# ONE SYDNEY HARBOUR

## BARANGAROO

R5 SUPPLEMENTARY DESIGN STATEMENT FOR S4.55 MODIFICATION - RESPONSE TO SUBMISSION  
March 2021

Proposed Roofscape and Lift Motor Room - Plan

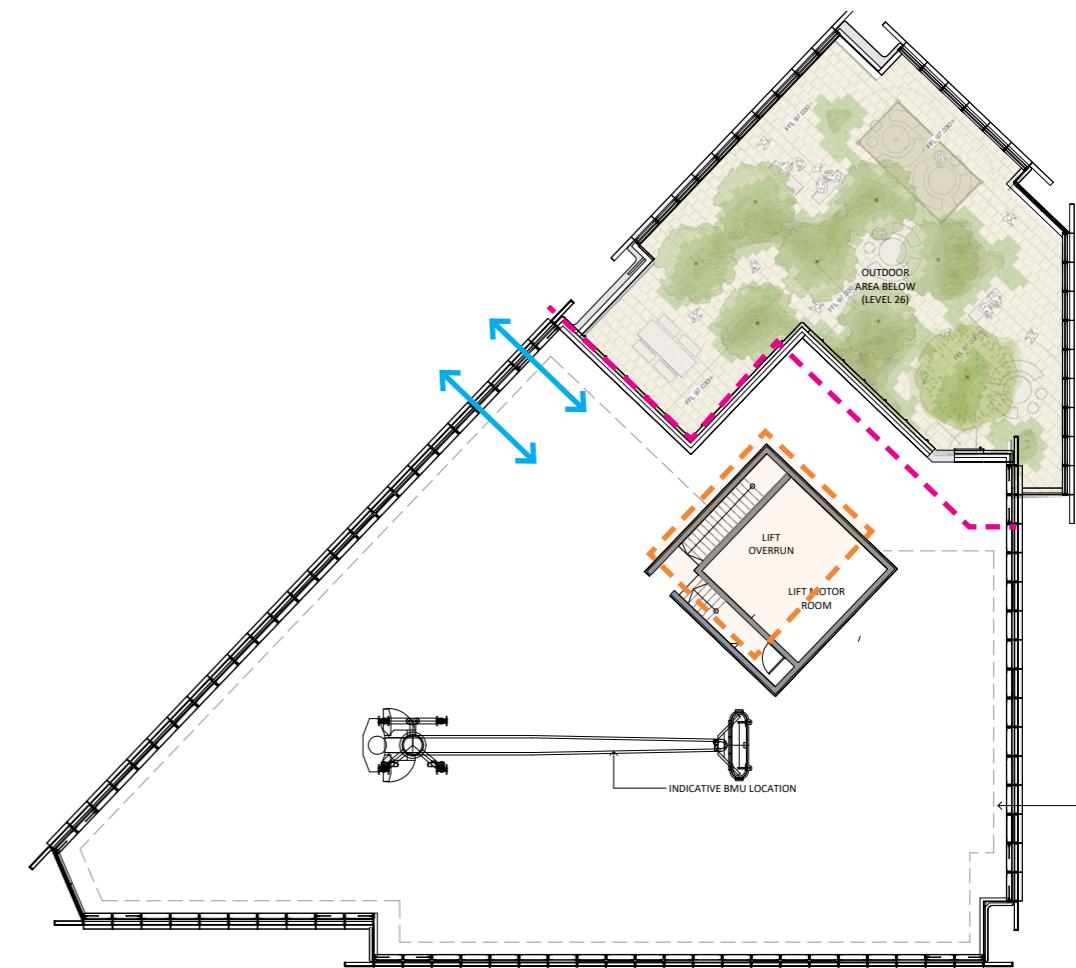
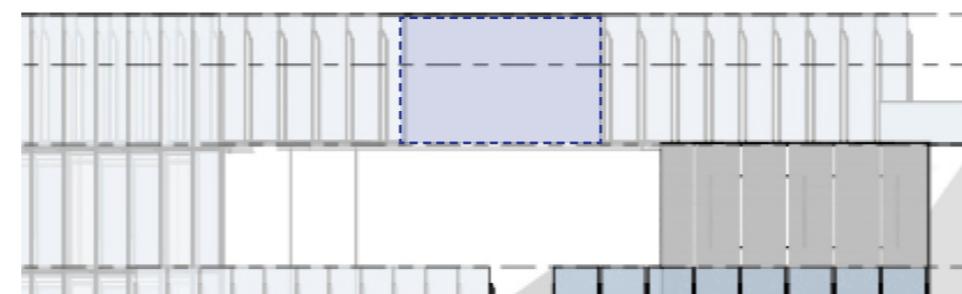
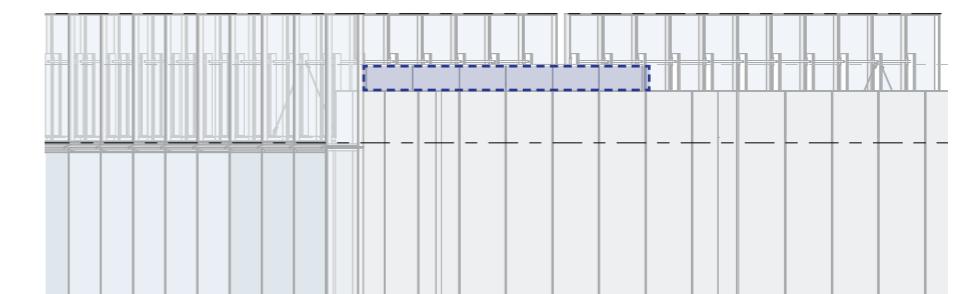
A minor refinement in the location and configuration of the Lift Motor Room (LMR) is proposed.

The proposed LMR has a larger footprint but a smaller height, as shown in the following schemes. The ability to provide essential maintenance strategy to support the vertical transportation infrastructure is enhanced with the amended location.

Moreover, this change in height is important to ensure an efficient relationship with the Building Maintenance Unit (BMU), allowing it to operate above it, and to have an unobstructed reach to the complete facade.

The south facing cladding (highlighted in magenta) also underwent changes. First, it was shifted outwards to ensure proper clearance between the BMU, LMR and services on that level. Secondly it also increased in height to function as a parapet for the roof and partially cover the LMR as shown in the elevations below.

The landscape area on L26 was also reviewed. An important factor in that revision was the shift of louvres on L26/L27 Plantroom. Previously facing the terrace, these louvres are now proposed to face Hickson Road, allowing the residents to use the terrace space in its entirety as shown in light blue.

Proposed APT 2 and 3 Layouts without shaft

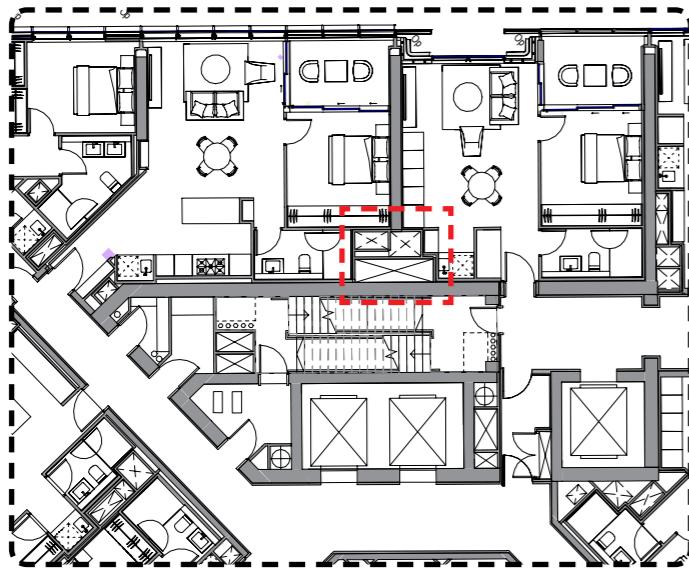
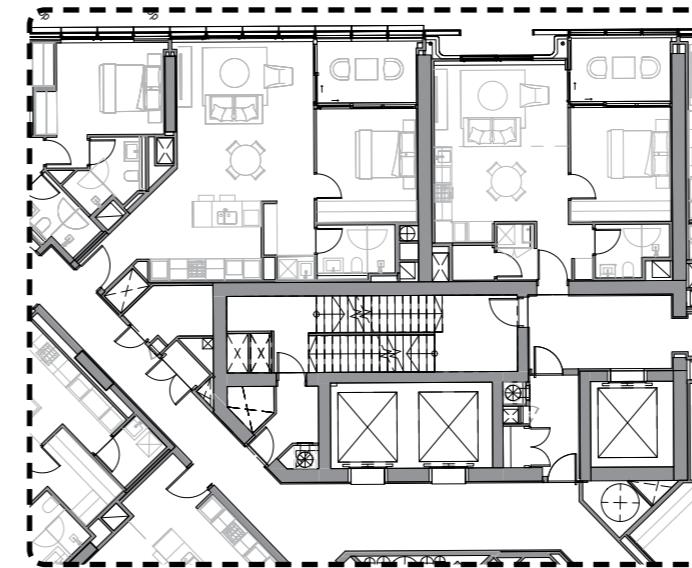
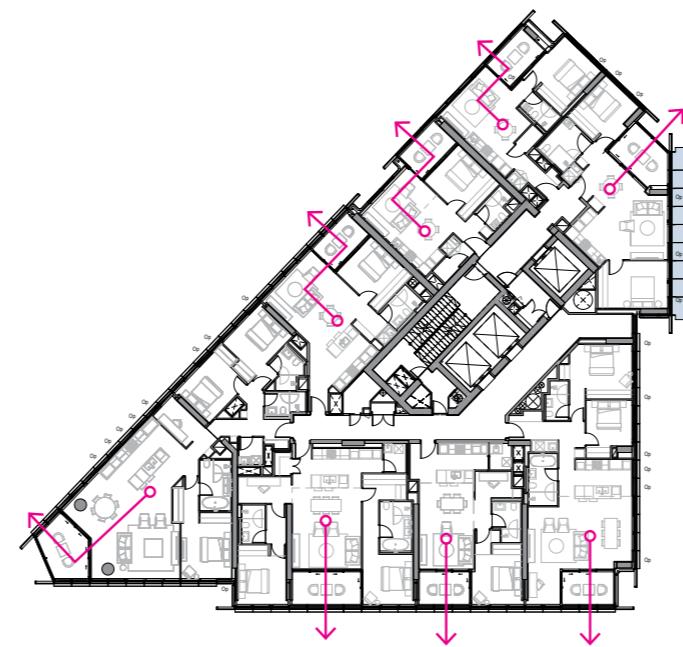
The bathroom exhaust strategy has been revisited to further simplify the floor plate and the riser configuration throughout the tower.

The design intent is to exhaust mixed bathroom and laundry air (for all apartments with the exclusion of the skyhomes) to the balcony zone.

North West Elevation - Proposed

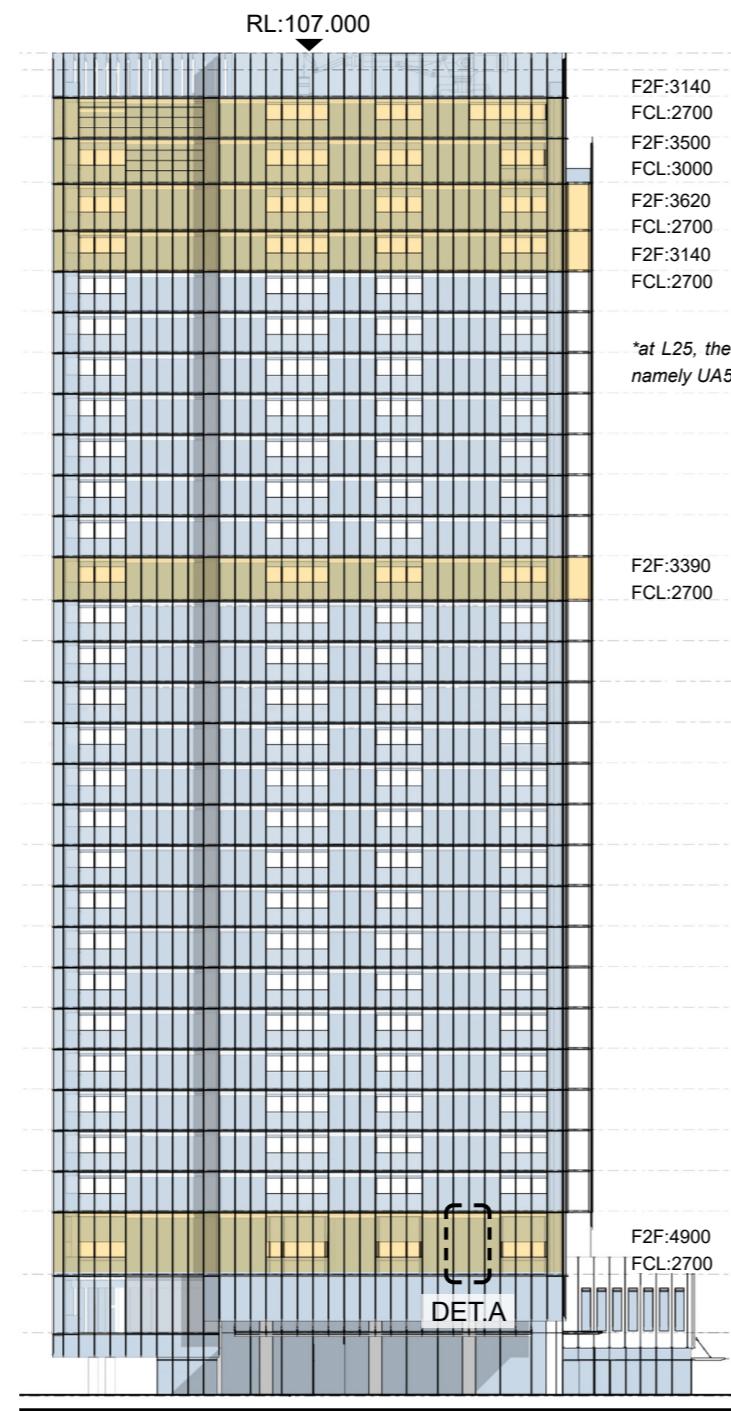
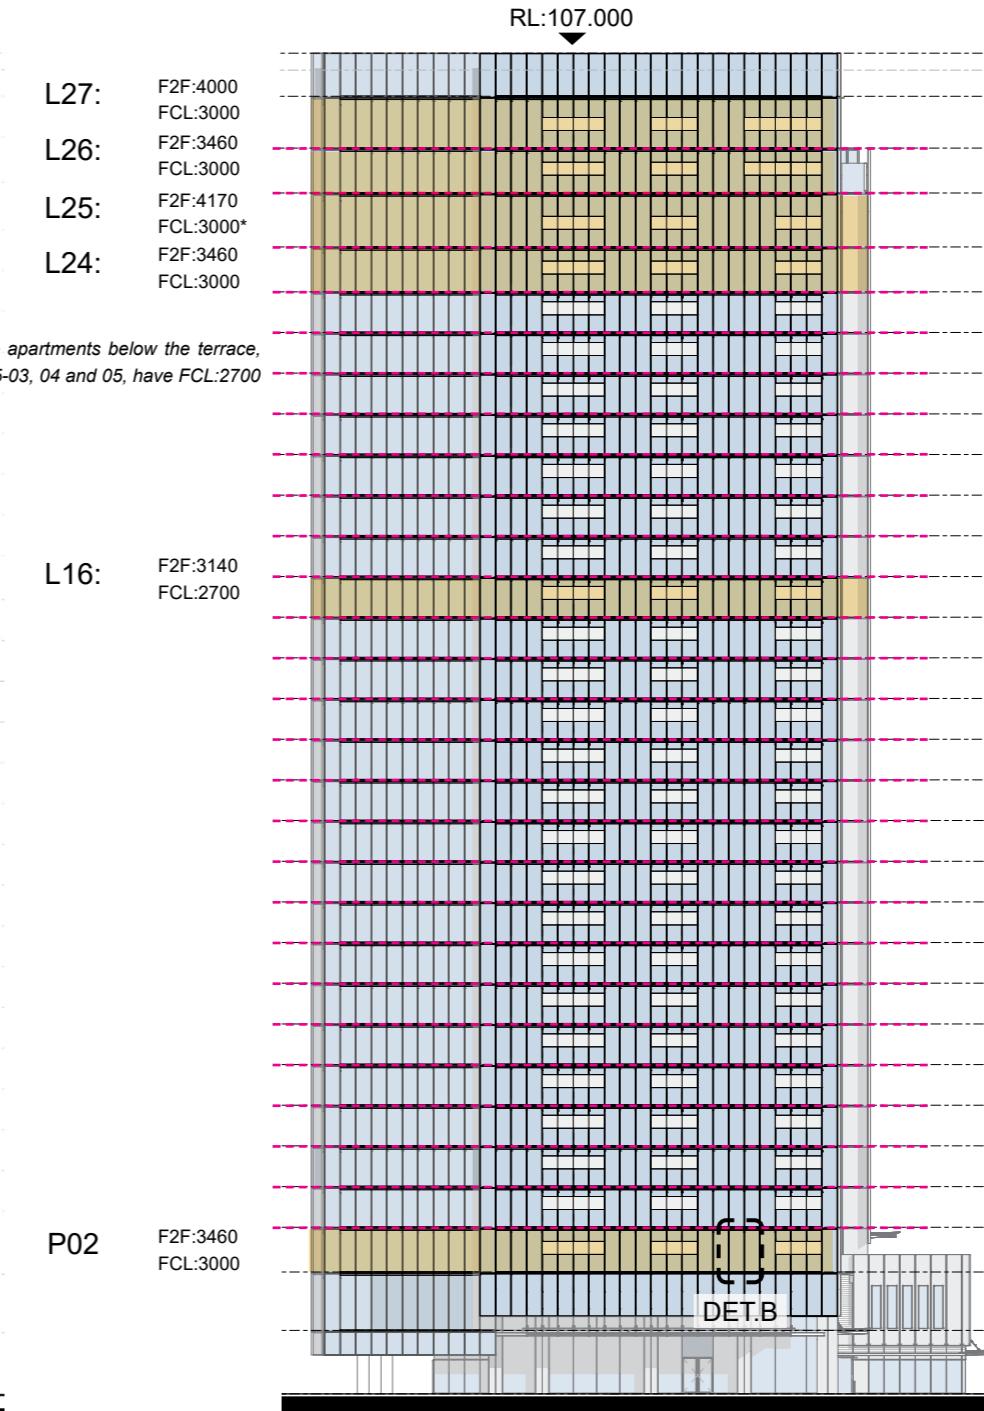
In order to better serve the functions in the tower, the levels in the building were reviewed. The main driver of this amendment was the reduction of P02 level from a 4.900m floor to floor (F2F), matching R4A & R4B, to 3.460m.

This was done in order to reflect the different nature of the P02 level across the precinct. In R4A and R4B this level houses amenities spaces with large open spaces and high finish ceiling levels. However, the R5 building P02 level houses apartments, not justifying the extra F2F height. To preserve a sense of uniqueness to the level, while addressing its function, it was proposed to adopt the 3.460m height mentioned, allowing the apartments at that level to have taller 3.000m Finish Ceiling Level (FCL).

To maintain the tower roof line, L16 and L24-27 were updated on their F2F and FCL as shown in the following schematical elevation, resulting in an increased number of 3.000m FCL apartments.

### 2.7 Tower Facade Panels Layout

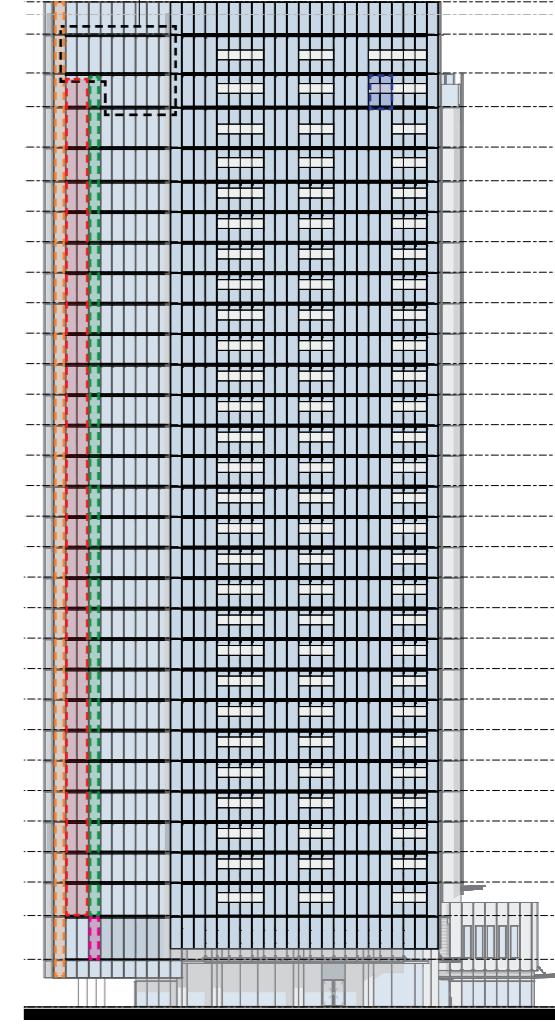
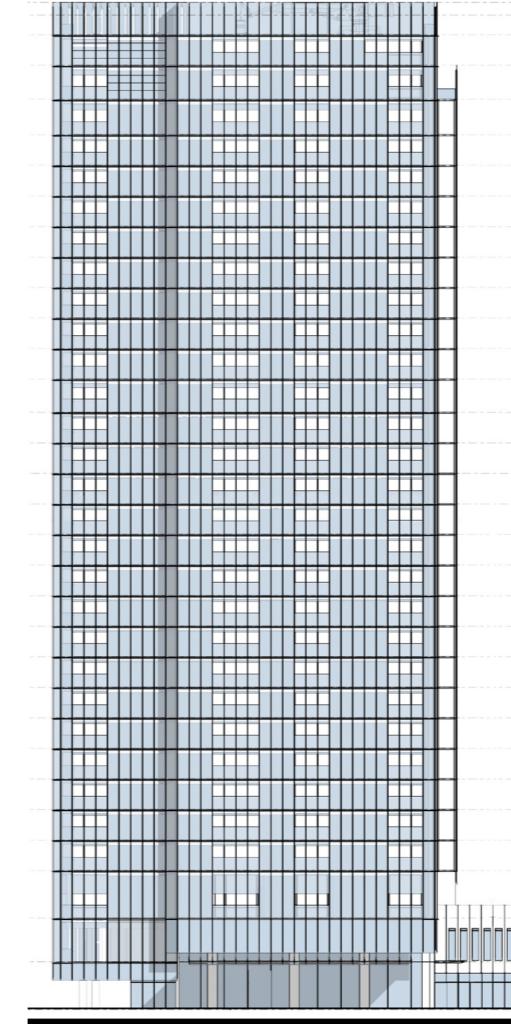
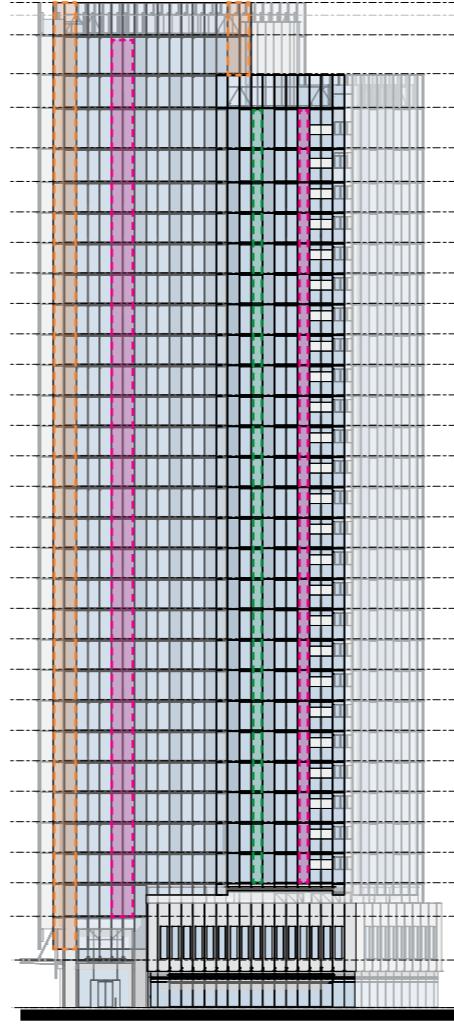
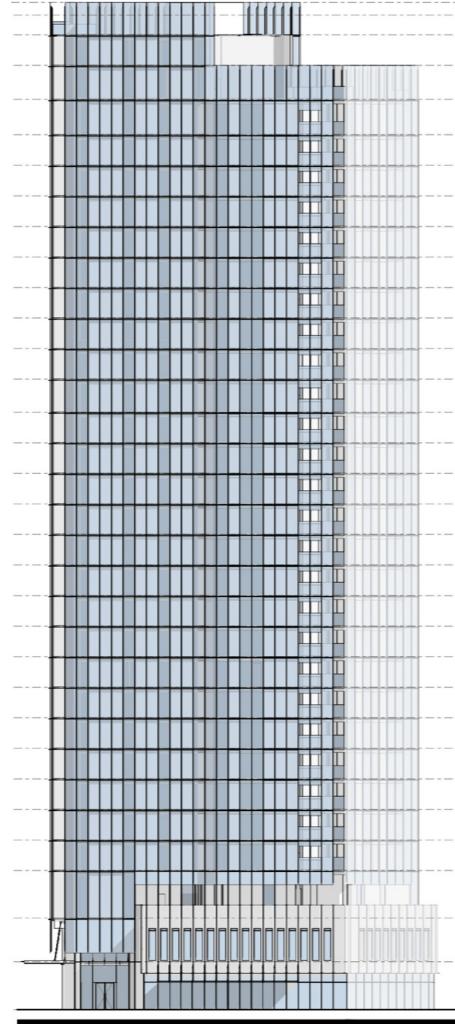
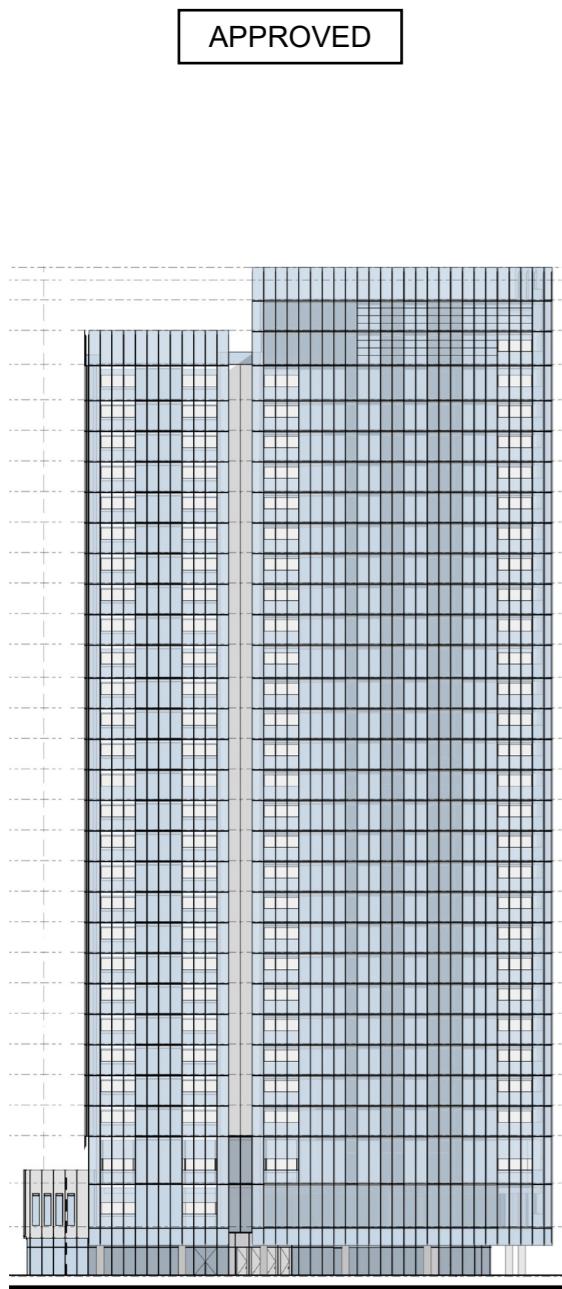
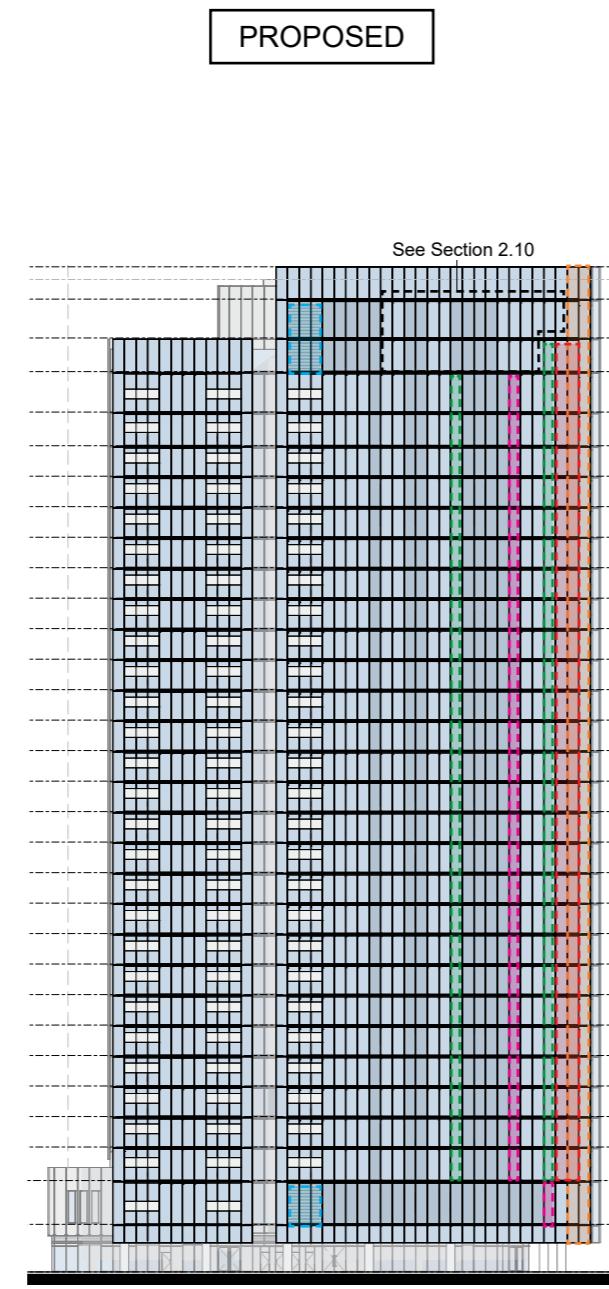
As a result of the design improvements described in the previous sections, the overall building facade underwent some refinements in the facade panel layouts to better suit the proposed solutions.

Most of the new facade modules are a result of the additional GFA and the step-out of the facade towards the park front as shown in section 2.1. The exception are the panels highlighted on the upper portion of Elevation 1, as they are consequences of the amended roof line described in section 2.4

The interchanging panels typologies that are proposed to be replaced by Balconies, Open Cavity Facades and Spandrel panels are consequences of the amendment proposed in section 2.3.

The proposed louvre panels on L26/L27 are consequences of the upper terrace redevelopment as shown on Section 2.4. Three other louvres are proposed on P01. They are aligned with the upper ones and are proposed to reflect the mechanical nature of that level and to be used for stairs pressurization intake.

Finally, the change of the tip balconies to full height laminated glazing is further detailed on Section 2.9.
